DRP ADVICE 5.1

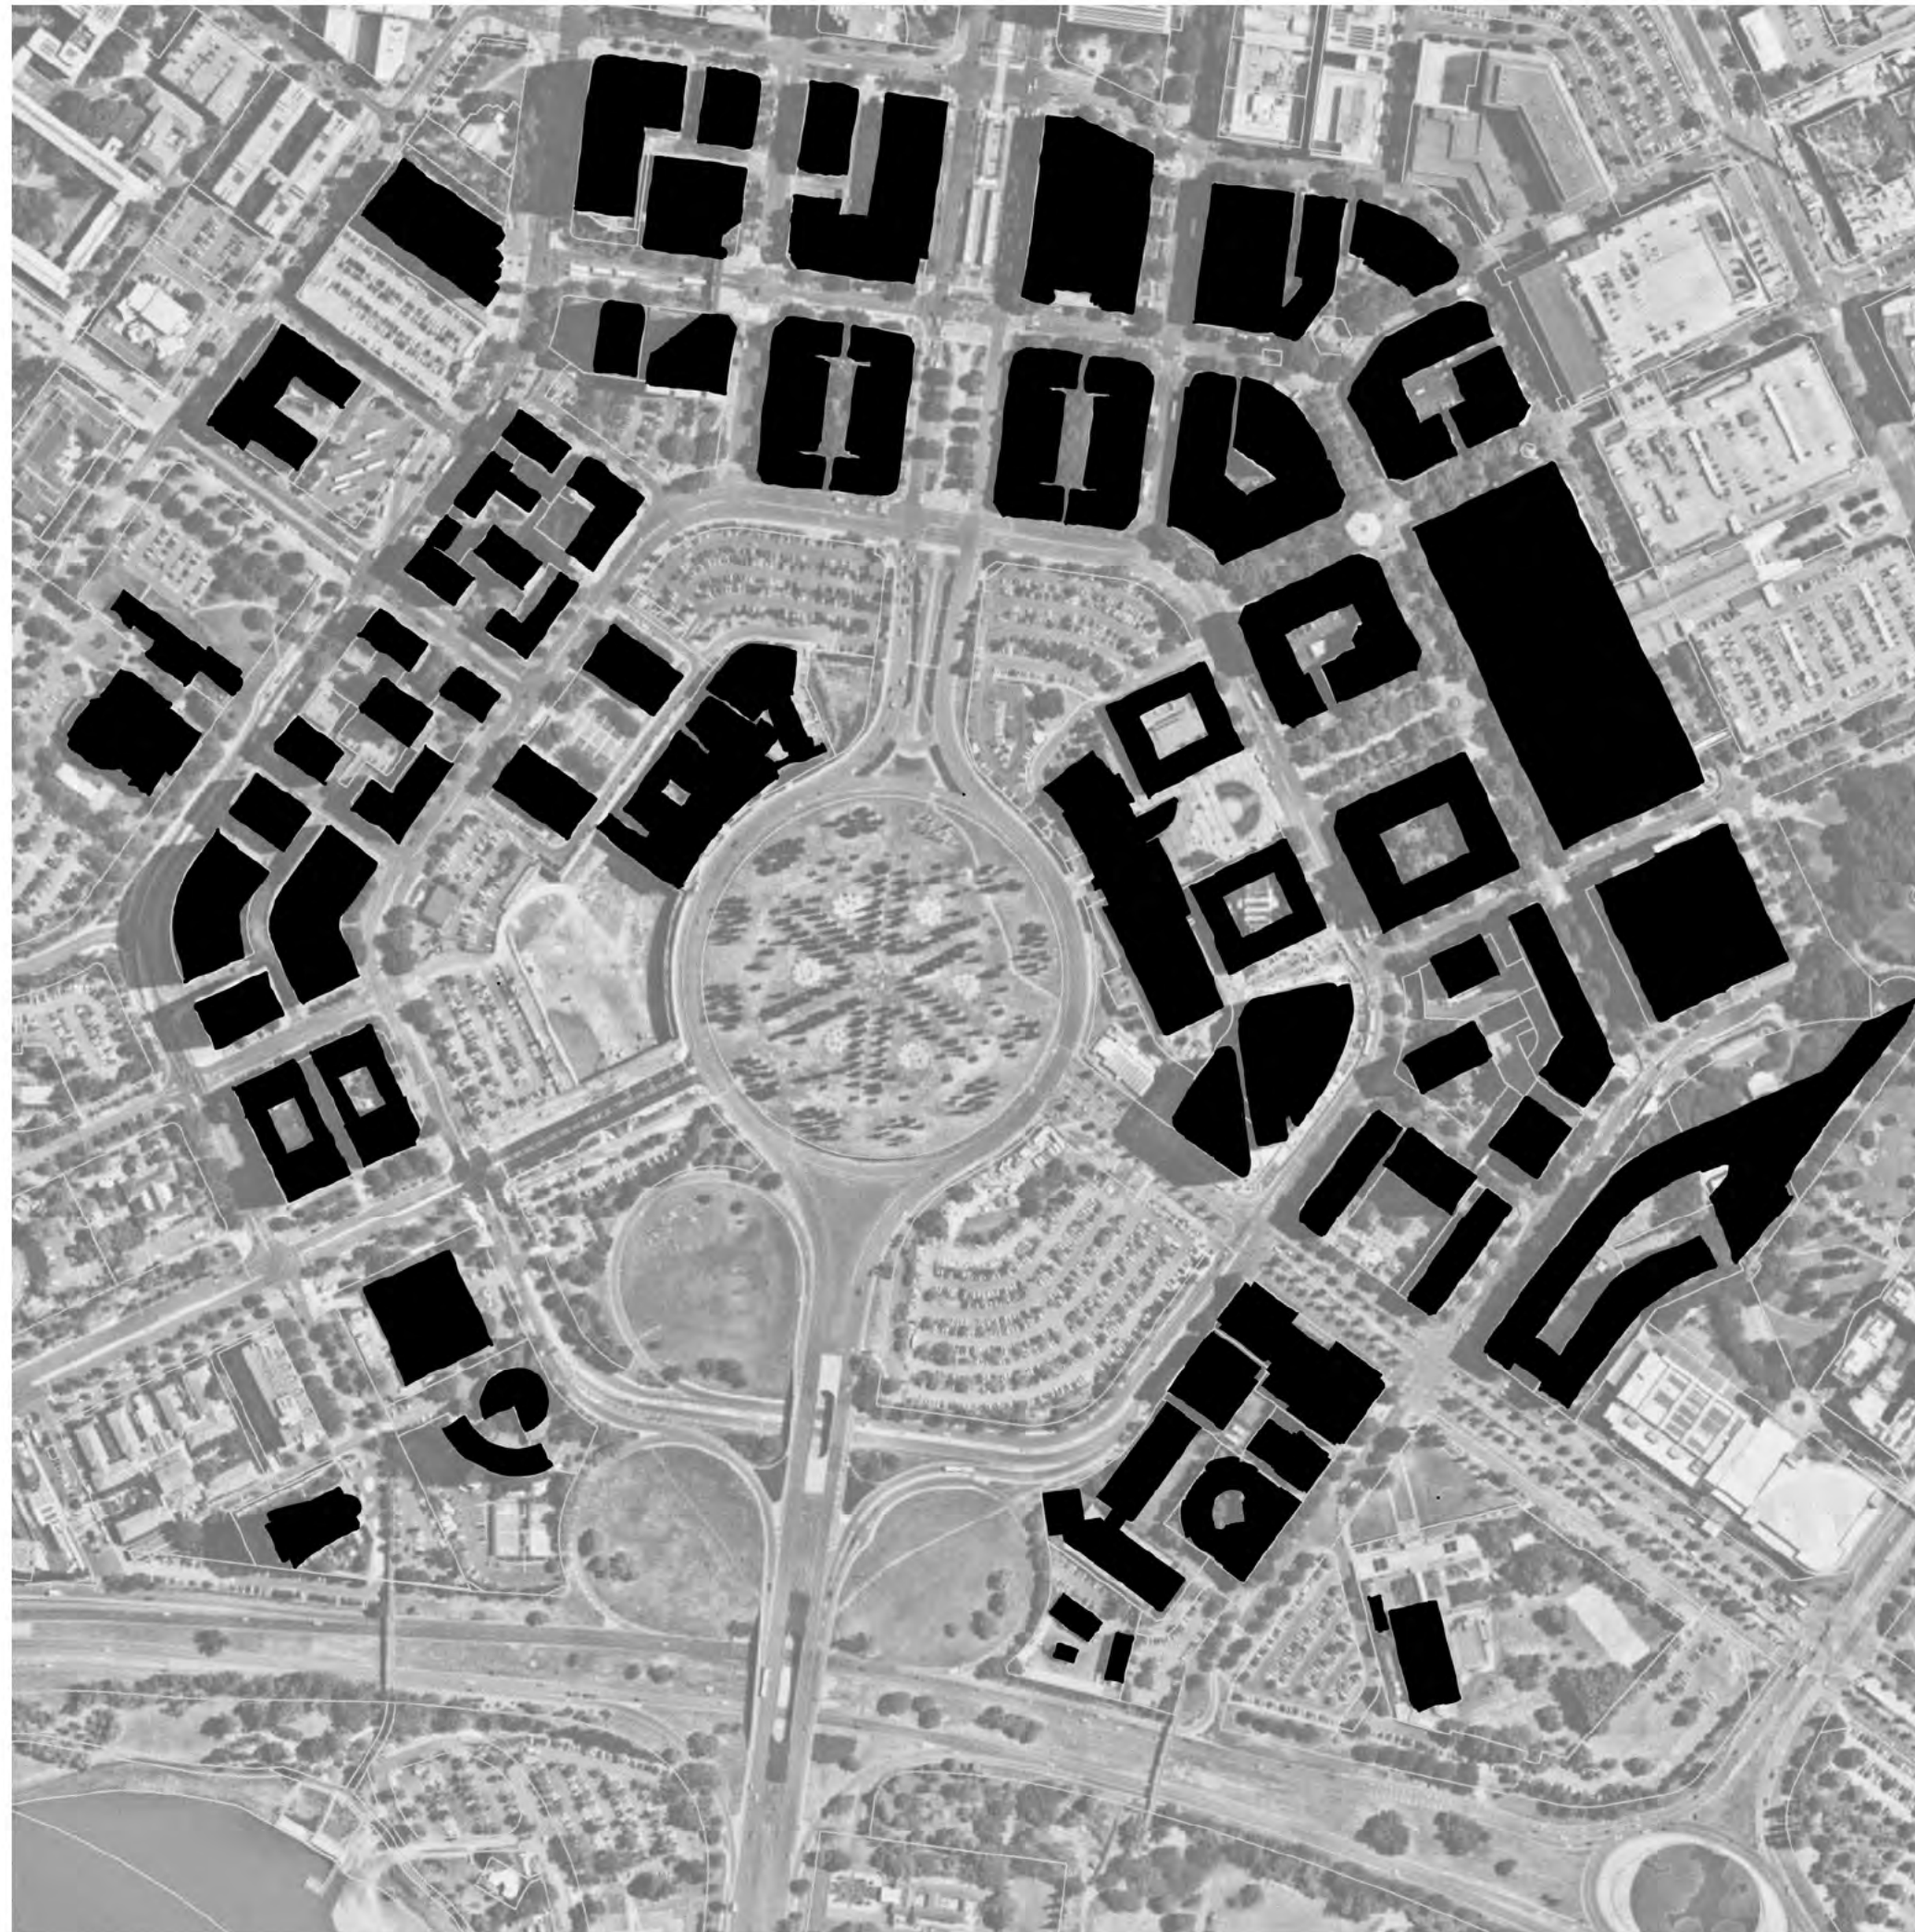
The geometry of built form presented in the current proposal is considered by the Panel to require reconsideration specifically in relation to the proposal's response to the urban geometry at the 'knuckle' on London Circuit. The Panel strongly recommends the proponent explore alternate options for siting, articulation and transitions in scale of the built form which better responds to the existing built form of the precincts surrounding City Hill, which are generally built up to the site boundaries and contain central courtyards or substantial throughways. This should include consideration for future block structures, new local streets, pedestrian and cycle pathways, land use and planning controls for adjoining and adjacent sites and future road levels to London Circuit.

Respond to urban form

DRP ADVICE 1.2

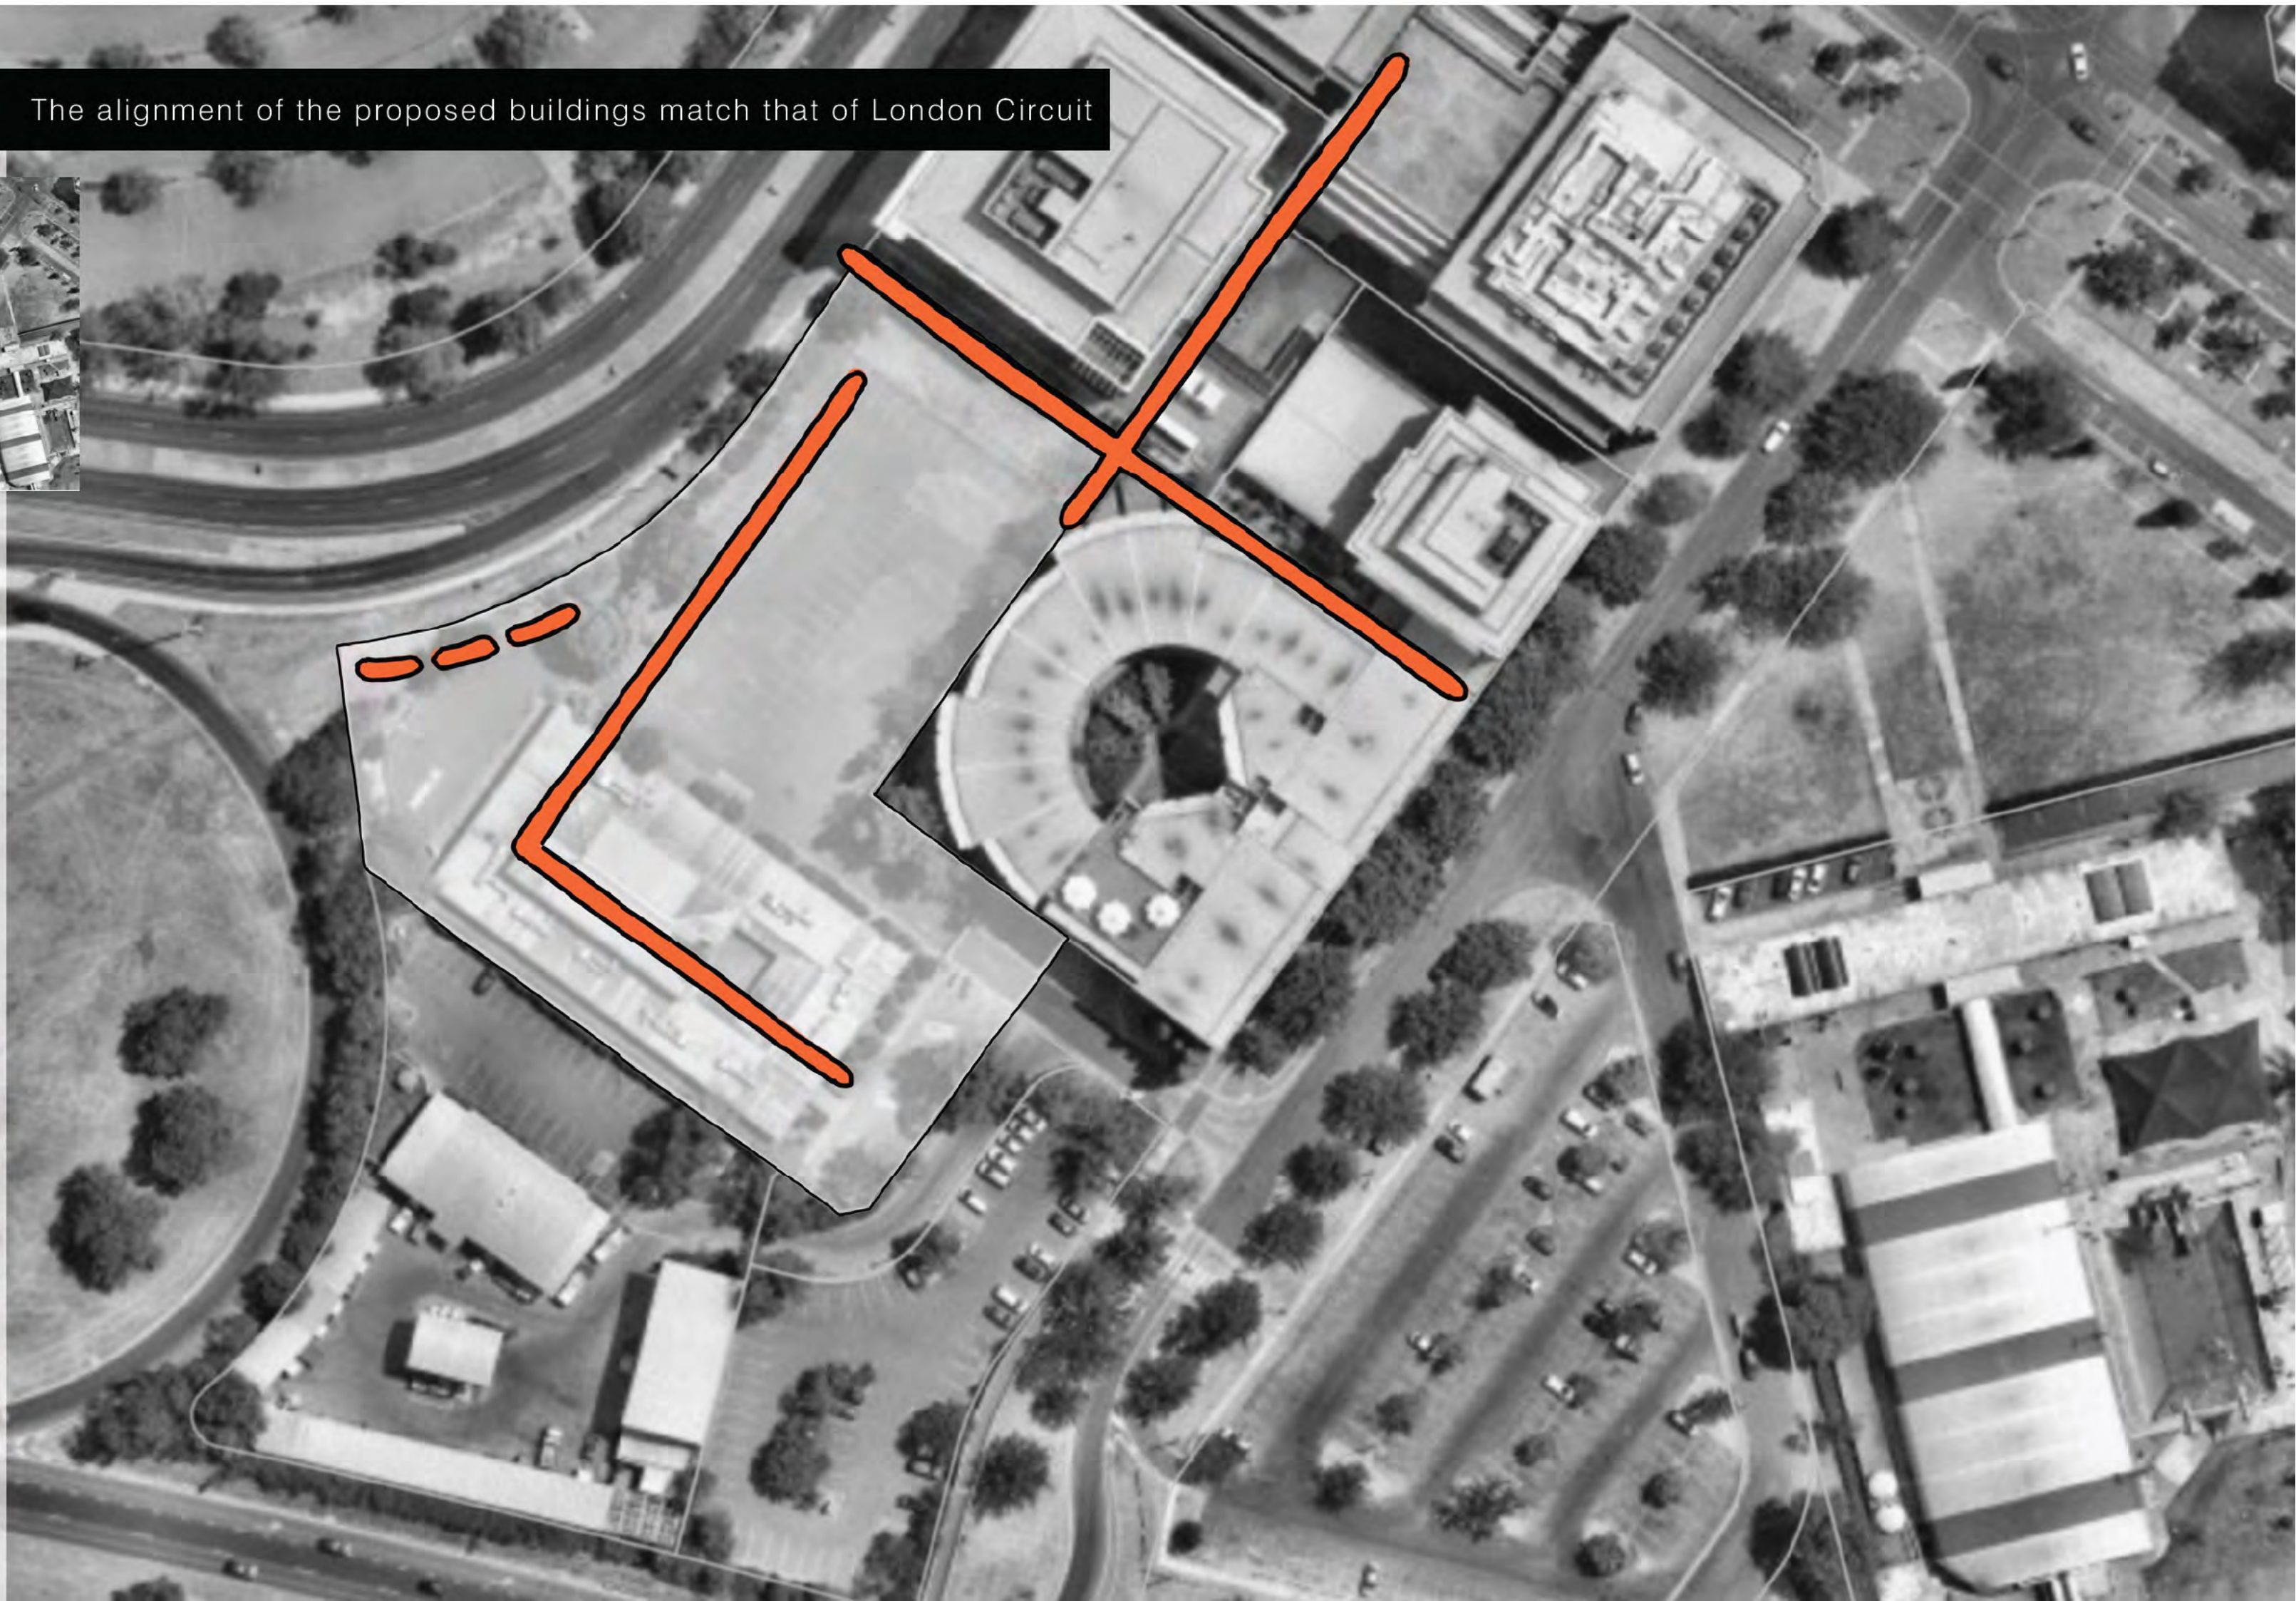
The proposed alignment of the residential and commercial buildings is not supported by the Panel as it is considered to lack the required formal response in its address to London Circuit or provide an appropriate civic response commensurate with the prestigious site location in the National Triangle. Acknowledging the proponent's intent for the commercial component of the proposal to align with London Circuit and the adjacent DFAT building, the Panel considers that the scale and fragmented nature of this offering does not provide a satisfactory civic response in its geometry or scale. **Furthermore, the Panel is unconvinced that the alignment of the proposed residential buildings to Parkes Way is justified, noting that the form and scale of the residential buildings are considered by the Panel to dominate the proposal.** The proponent is therefore encouraged by the Panel to return to 'first principles' including reconsideration of their understanding of the site context and planning principles. Additionally, **the Panel strongly recommends that the proposal should more formally address and align to the London Circuit geometry through greater consideration for axis' in Griffin's plan.** The Panel recommends that this be demonstrated by presenting options at the next design review session. (See also 5.0 and 6.0)

The alignment of the proposed buildings match that of London Circuit
